**Proposed changes to add verification to Clause 99:**

**Figure 99–2—MAC Merge Functional Block Diagram**

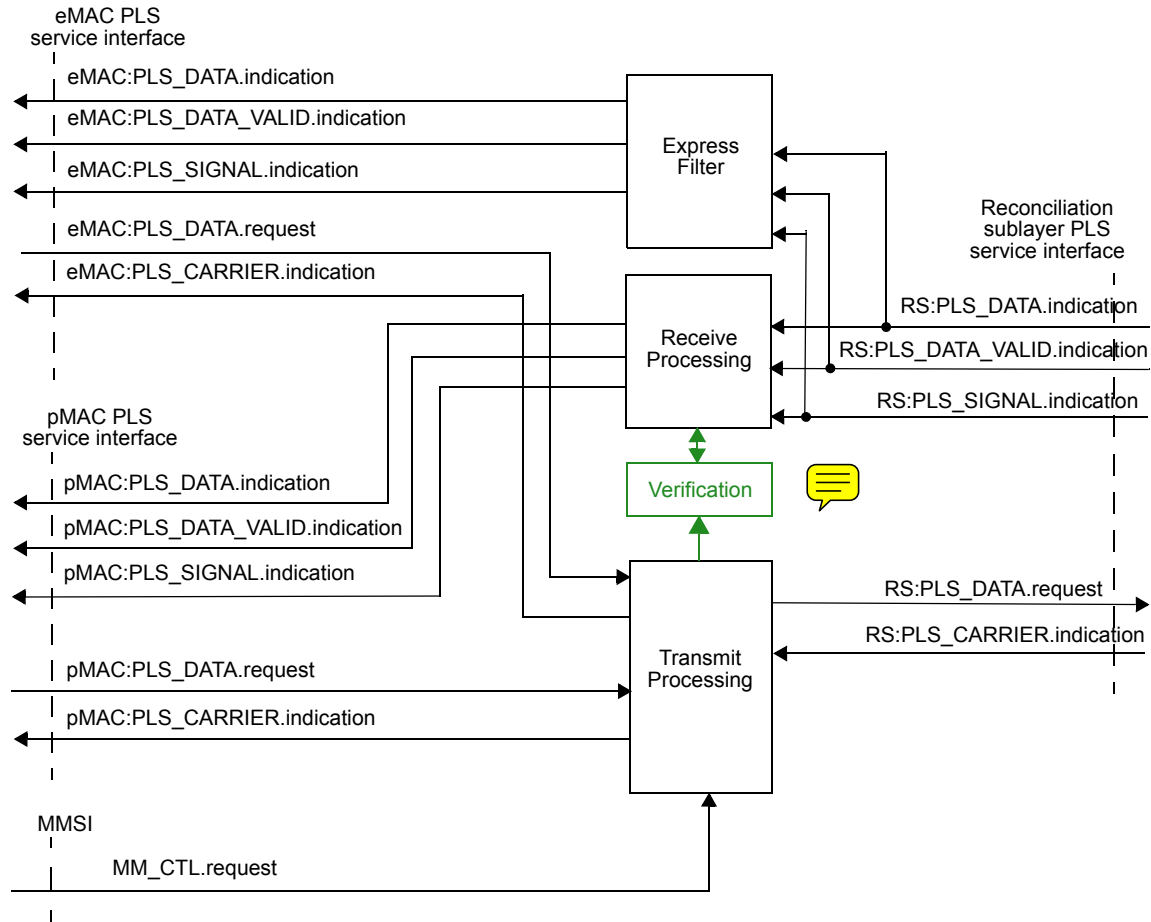
Figure 99–2 provides a functional block diagram of the MAC Merge sublayer.

Figure 99–4—Transmit Processing State Diagram

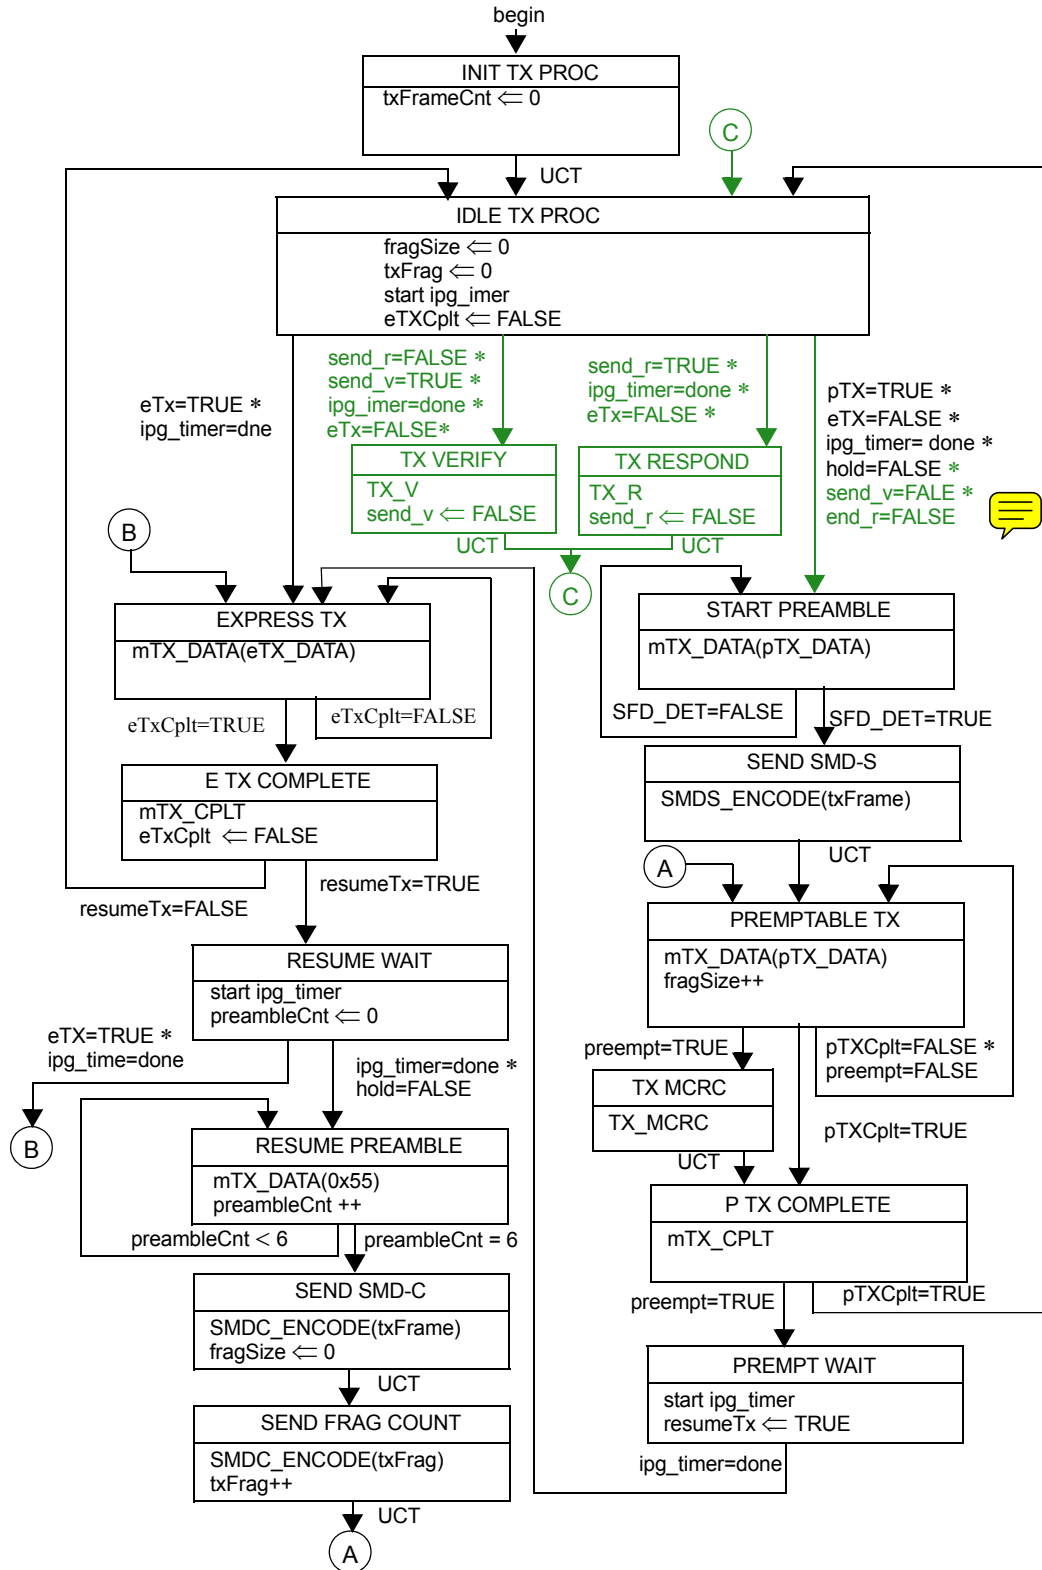
The Transmit Processing State Diagram is shown in Figure Figure 99–4. The Receive Processing State

Figure 99–5—Receive Processing State Diagram

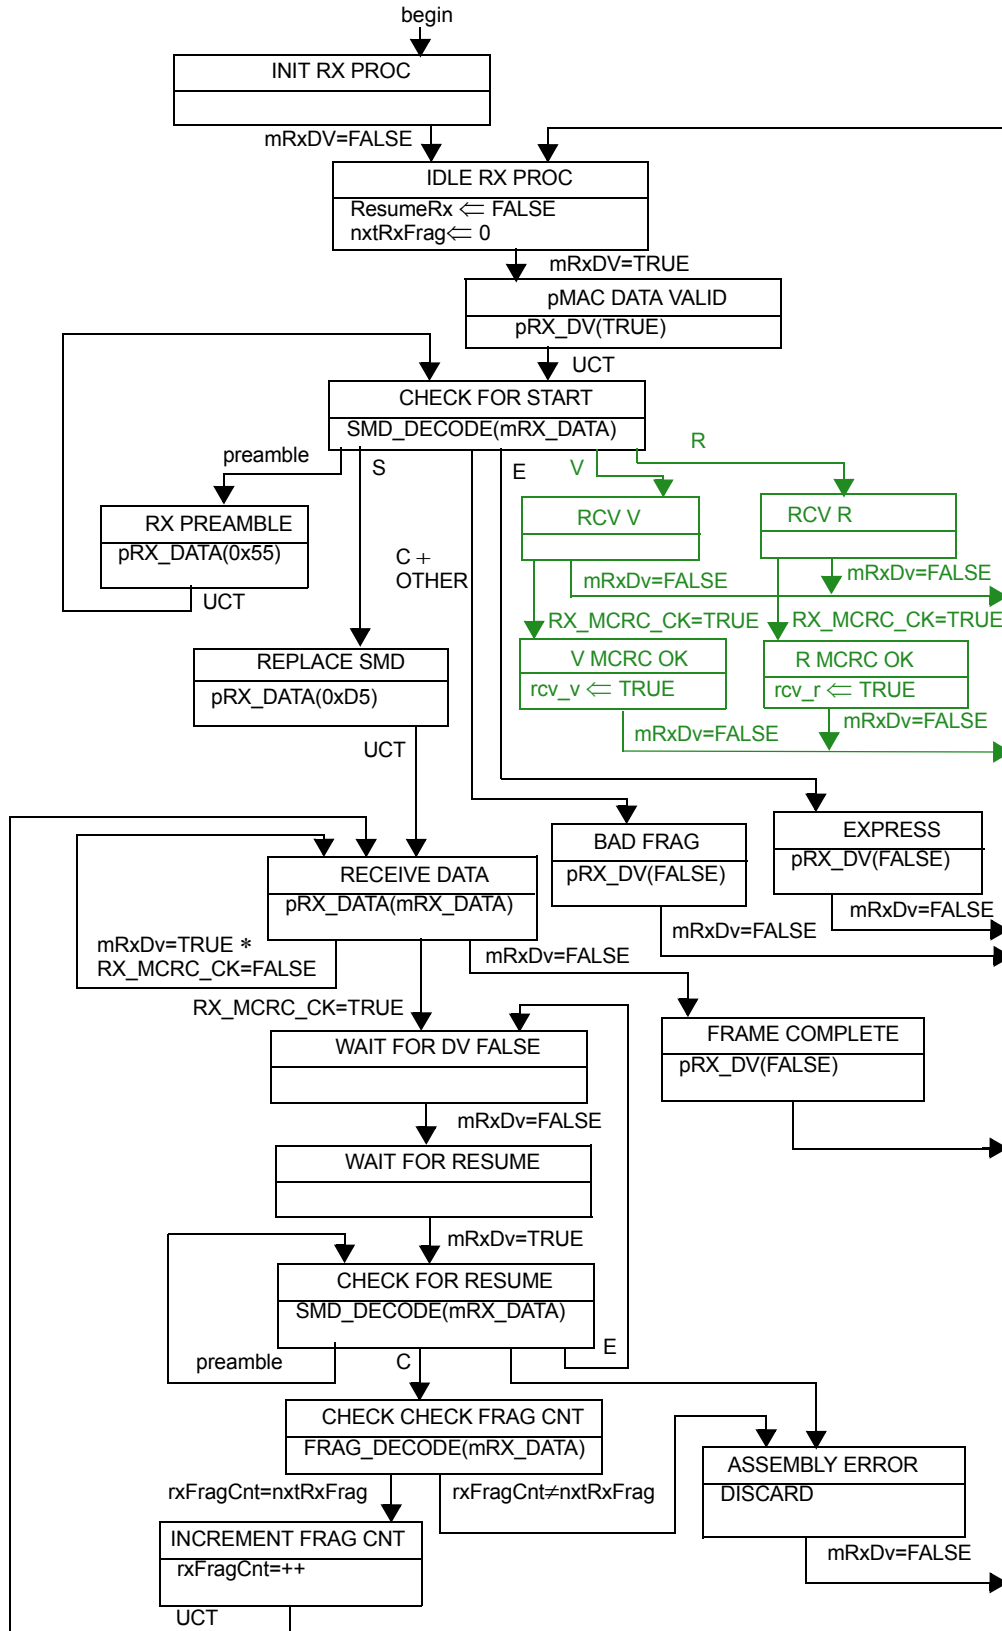
Diagram is shown in Figure 99–5. The Express Filter State Diagram is shown in Figure 99–6. [The Verify](#)

Figure 99–7—Verify State Diagram

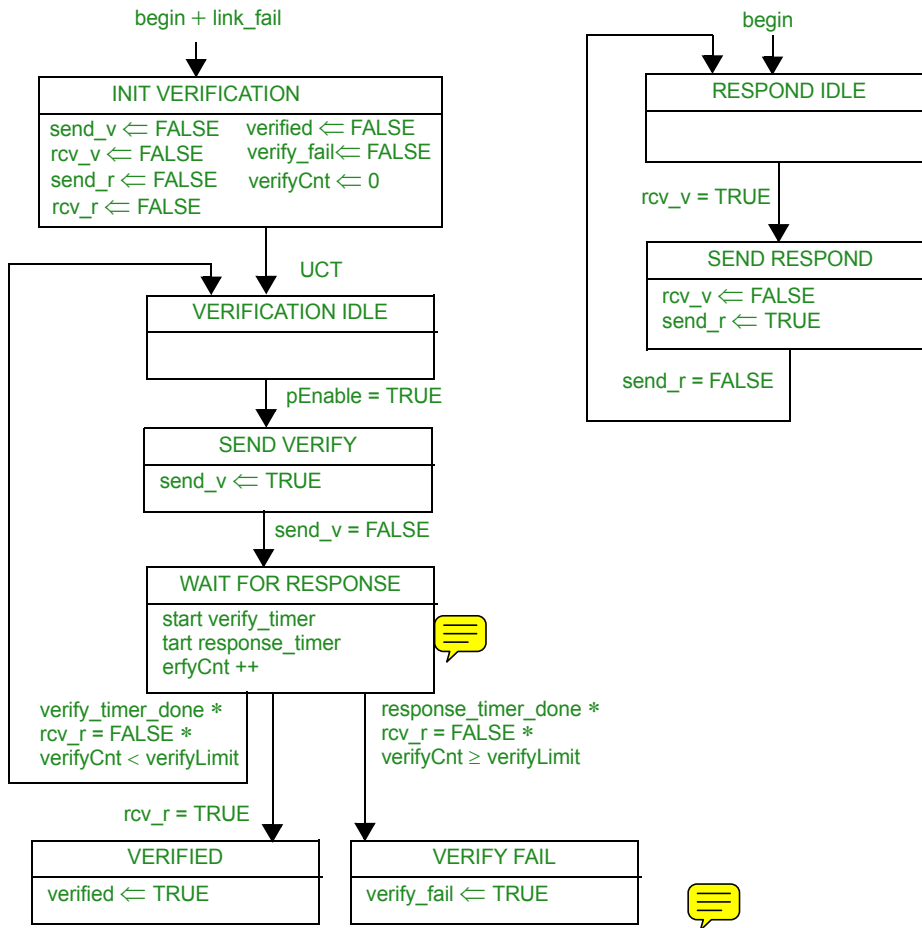
If preemption capability is enabled and has not been verified, MAC Merge initiates transmission of a verify mFrame. A verify mFrame has 7 octets of preamble,(0x55) an SMD-V, 60 octets of 0x00 and an MCRC.

Transmission of a verify frame may be repeated to allow verification in the presence of noise causing bit errors.

When an mFrame with an SMD-V and a correct MCRC is received, a response mFrame is sent. A response frame has 7 octets of preamble (0x55), an SMD-R, 60 octets of 0x00 and an MCRC.

When an mFrame with an SMD-R and a correct MCRC is received, preemption capability is verified.
